IPL appreciates the opportunity to respond to the comments submitted by interested parties regarding its 2016 Integrated Resource Plan (IRP). The attached response document addressed key topics raised.

**Indianapolis Power & Light Company Reply to Stakeholder
Comments on the 2016 Integrated Resource Plan
April 28, 2017**

Figure 2 – Scenarios and Sensitivities

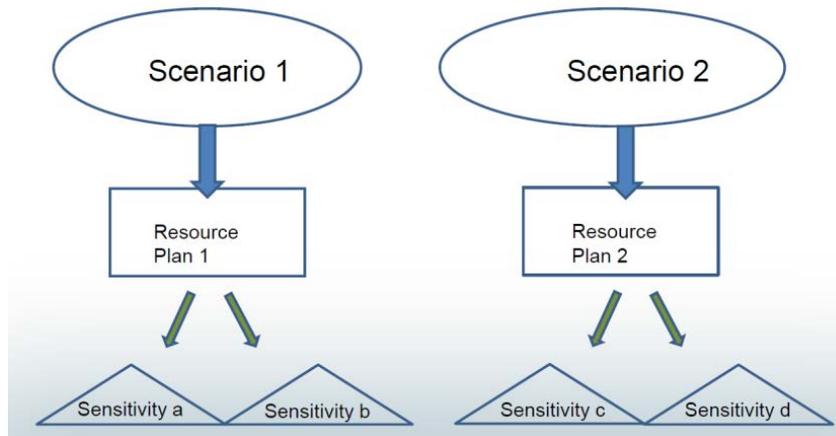
The Commenters take issue with the development of the candidate portfolios and the comparison of all scenarios to the Base Case. They believe that this comparison gives the Base Case a “baked in” advantage over all of the other portfolios. IPL does not agree with this statement and used the Base Case as a means to compare how the portfolios perform under a common set of assumptions to levelize results. This results in an “apples to apples” approach.

The Commenters believe that TVA’s methodology is superior because they compare five distinct portfolios against five different scenarios. The result is a 5x5 “matrix” of results comparing all of the results against each other. Figure 1 below contains results from TVA’s 2015 IRP.¹

IPL considers the “Scenarios” in TVA’s IRP to be sensitivities, where each portfolio was modeled against the same set of assumptions that were deterministically varied (i.e. one or more variables were changed by a fixed and known amount). IPL chose in this IRP cycle to conduct the sensitivity analysis through a stochastic simulation, although both a deterministic and stochastic sensitivity analysis could be conducted, which was the case in the TVA 2015 IRP.

IPL is open to including a comparison of each portfolio against the other scenarios in its next IRP. It is important to note, however, that this type of analysis does not lend well to choosing a single preferred resource portfolio and should not replace a complete and robust sensitivity analysis. TVA did not choose a single portfolio or strategy in their 2015 IRP – they instead established “guideline ranges for key resource types (owned or contracted) that make up the target power supply mix”. The Commenters criticize IPL for reaching a similar conclusion in this IRP with the Hybrid Portfolio, but the Commenters also would like the same analysis as TVA. Additionally, in the end, TVA relies on the “Current Outlook” scenario, which is described in a similar nature as a Base Case, as a basis to develop their final recommendation.

Figure 3 – **Representative alignment between IPL load and wind production**

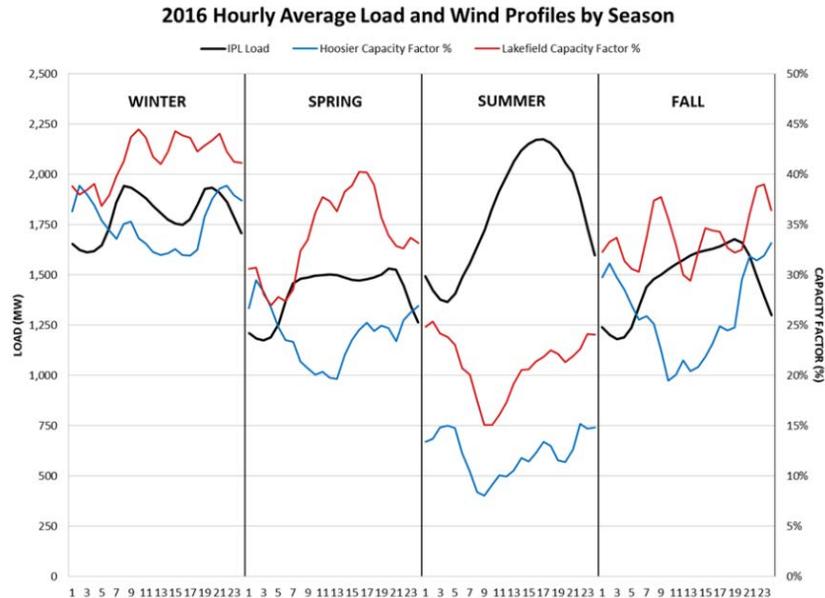
The Commenters recommended that for the next IRP, IPL provide evidence that the peak output of wind farms indeed does correlate with IPL's minimum loads. Figure 3 shows the hourly average IPL load and the hourly average capacity factors for IPL's wind units by season in 2016.

Figure 3 also shows that for each season in 2016, the capacity factors for IPL’s wind projects are often the highest late at night, which coincides with low loads. The 2016 data also shows that IPL’s wind units experience their lowest average capacity factors on summer days when IPL’s load tends to be the highest. Hoosier Wind Farm’s average capacity factors range from less than 10% to 15% in the summer and Lakefield’s average capacity factors range from 15% to about 25% in the summer. However, as shown in Figure 3, the capacity factors for the wind units increase in the spring and fall seasons when load is generally lower.
